Re: Consultation on an Application

Planning Application Ref: PL/26/0277

Proposal: Change of use of rear garden of No.80 from residential (C3) to a mixed use (sui generis) residential and childcare nursery with the erection of two outbuildings used to accommodate 15 FTE childcare spaces (Retrospective)

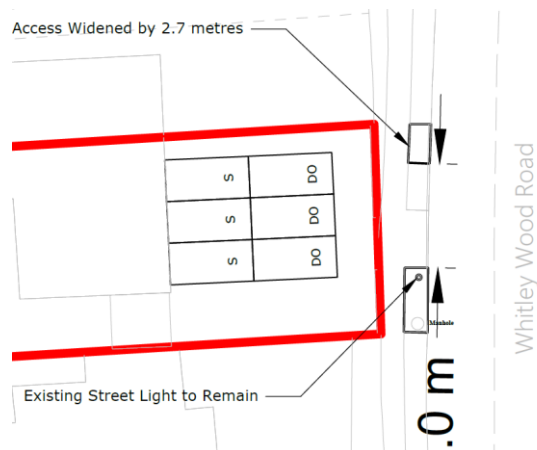
I note a retrospective tree survey has been submitted, in the form of a letter, 24th February 2026, by GHA Trees. It states that 'As this plan shows, new structure 2 sits within the RPA of T2 and beneath the crown of T2. Structure 3 sits within the RPA of G4 and beneath the crown of G4. None of the other trees shown are affected' and then goes on to say 'Whilst the structures are within the RPAs of T2 and G4, I am content that no harm will have occurred to these trees. Firstly, it is clear that soil levels have not been raised or lowered within the RPAs (see photo below) when installing the new structures.

If this information was provided to us prior to construction, we would have had no objections to the development in principle due to the quality of trees and limited impact. That being said, I note a slab has been used for the base of the outbuildings which would have been advised against, and we would have encouraged the use of ground screws. The use of a slab will have led to a level of soil compaction and won't allow water and air movement into the soil in the way that ground screws would have. I note there is no mention of impermeable liners being used for the concrete slab, so concrete leaching into the soil, which is toxic to trees, will likely occur. As this is in situ, I have no further comment to add, but this is disappointing.

Whilst the RPAs are plotted, there is no evidence of stem diameters and thus I am unclear on how accurate the RPAs are and how these have been calculated.
